DWN C.LACHALL	DATE 96/12/09	PROD ASSUR John B. L.	DATE 97-01-09	BOEING HELICOPTERS DCN		DWG NO. 145G0221				
CHK S.BRUNO	WT			DRAWING CHANGE NOTICE 77272	SH 1 OF 5	REV C				
ENGR M. Junch Jr	97/01/09	MAT'L & PROC		REASON REVISED ALIGNMENT TO AID IN SETUP & ALIGNMENT WHEN USED IN THE 145G0294 FIXTURE		DWG SH -				
STRUCT		ORG D.Gallagher	97/01/09	CODE D.IMP	MODEL/ITEM NO. CH-47D,414-100 / 26300					
PROJ Julian	97-01-20	CUST Hill Army	97/03/09	ORIGIN GSE 1459	CLASS PER MIL-STD-480 <input type="checkbox"/> CLASS I <input checked="" type="checkbox"/> CLASS II	CHANGE NO. PRRS5000E				
PL SH/ZONE	REPLACES	QTY REQ'D	CODE IDENT	PART OR IDENTIFYING NO.	NOMENCLATURE OR DESCRIPTION	ZONE	MATERIAL AND SPECIFICATION	HT TR	FINISH	PT MK

ENGINEERING DRAWING CHANGE CONTINUATION SHEET

-402 REGISTER WELDMENT

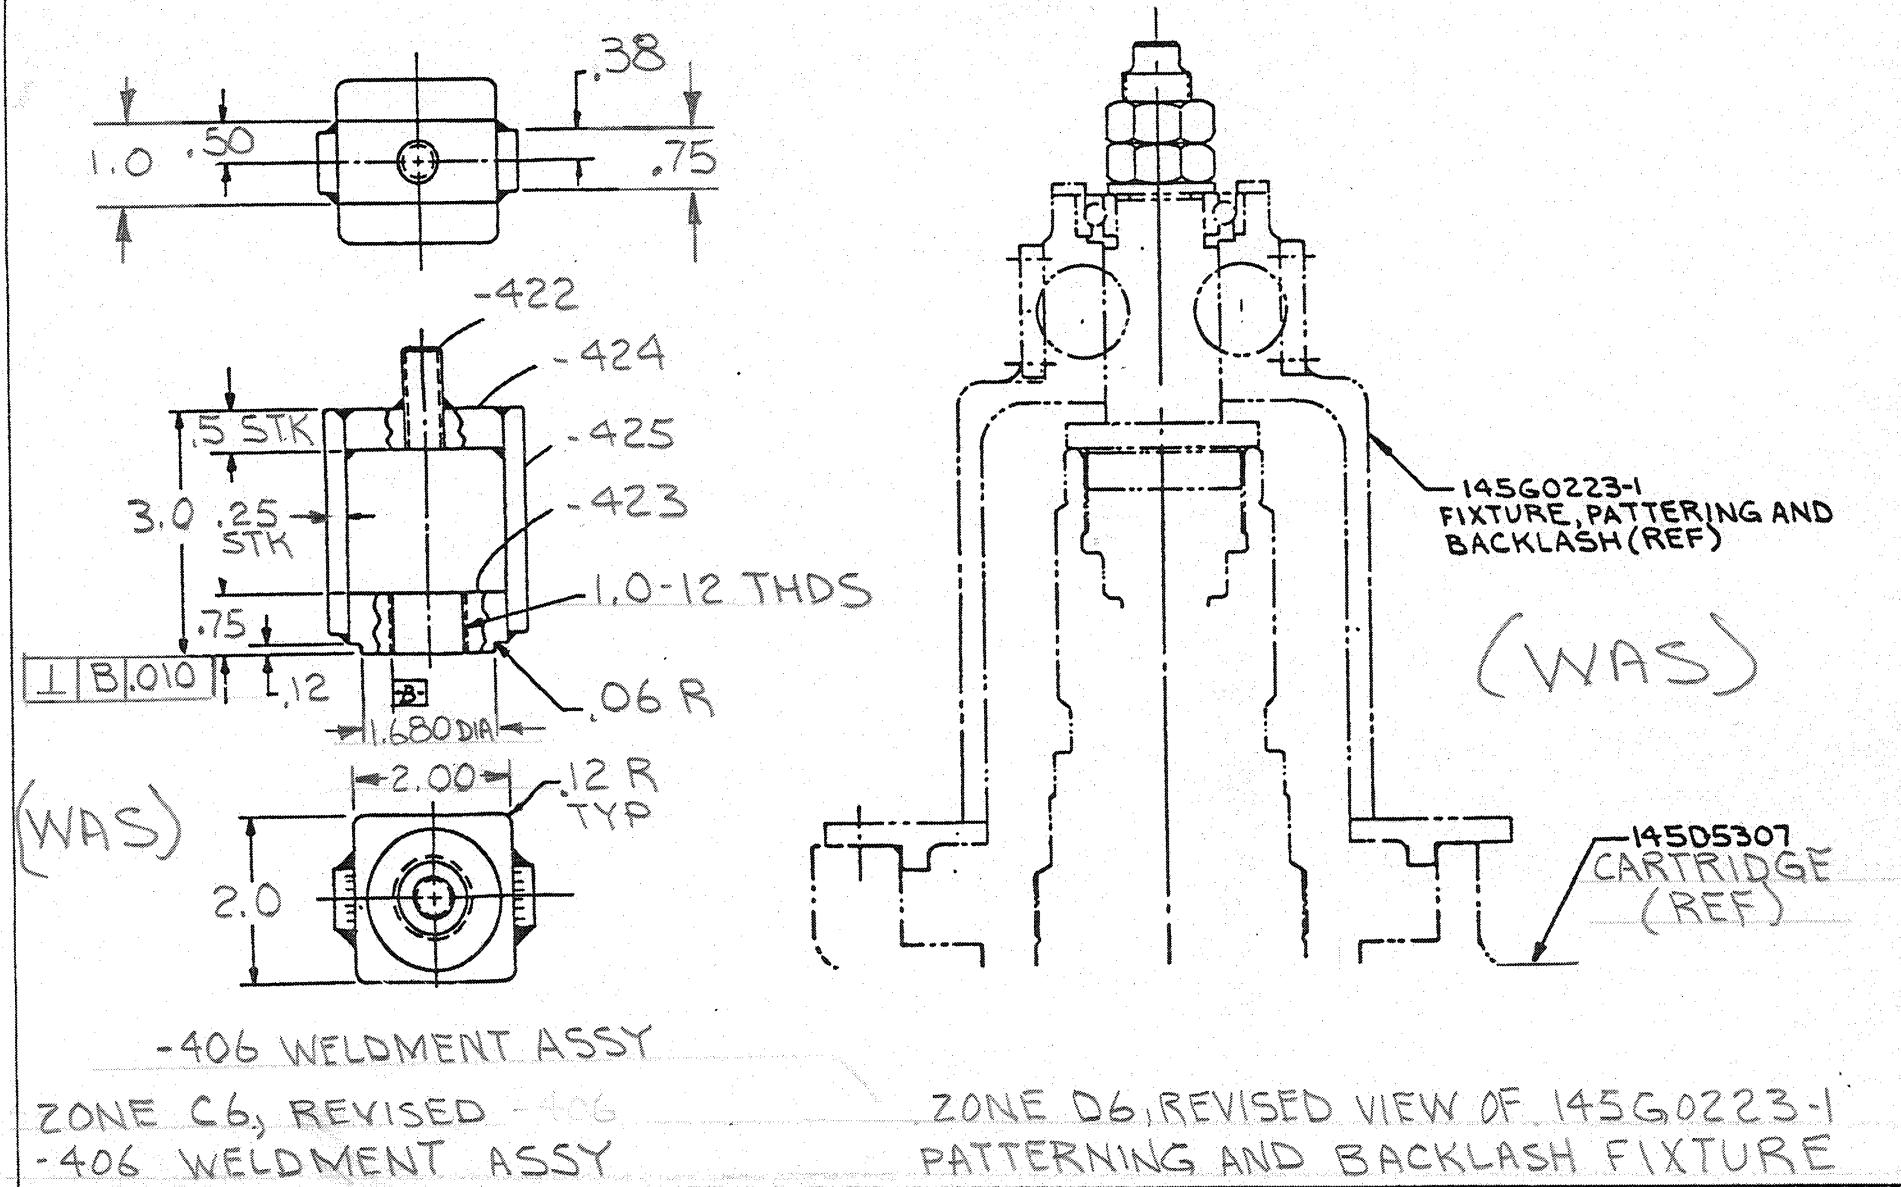
ZONE CT, REVISED -402 REGISTER WELDMENT

(WAS)

ZONE C7, REVISED -402 REGISTER WELDMENT
